Subject: Grand Gulf Nuclear Station
Docket No. 50-416
License No. NPF-29
Responses to NRC Questions Requested in a
NRC letter dated April 10, 1997, related
to Pressure-Temperature Limit Curves

GNRO-97/00058

RESPONSE TO REQUEST FOR ADDITIONAL INFORMATION
RELATED TO PRESSURE-TEMPERATURE LIMITS IN TECHNICAL SPECIFICATIONS
ENTERGY OPERATIONS INC.
GRAND GULF NUCLEAR STATION
DOCKET NO. 50-416

Figure 1: Upper Vessel Pressure-Temperature Limits

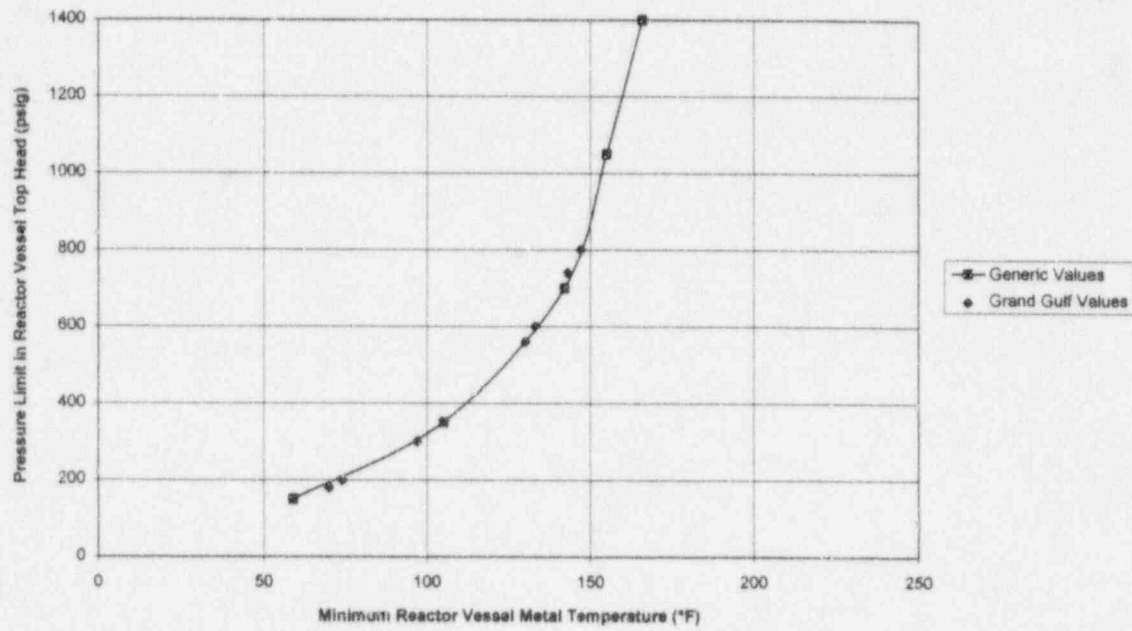
Confirm that the methodology used to generate pressure-temperature (P-T) limits for the bottom head and feedwater nozzle is the same as that provided by Georgia Power Company in support of the recent P-T limits for the Hatch Units. Otherwise, submit this methodology for Grand Gulf.

The highest non-beltline RT_{NDT} for a discontinuity in the upper vessel region is -20°F, the purchase specification limiting value for nozzles. The generic curve is applied to the Grand Gulf upper vessel by shifting P vs. $(T - RT_{NDT})$ values from the generic curve to reflect the nozzle RT_{NDT} value of -20°F.

Nominal Pressure (psig)	Vessel Metal Temperature (°F)
1400	166
1050	155
700	142
350	105
150	59

The values in the above table are plotted in Figure 1 ('generic values') along with the limiting values for curve BB' ('Grand Gulf values') identified as 'FW nozzle limits' in Table 1 of Reference 2.
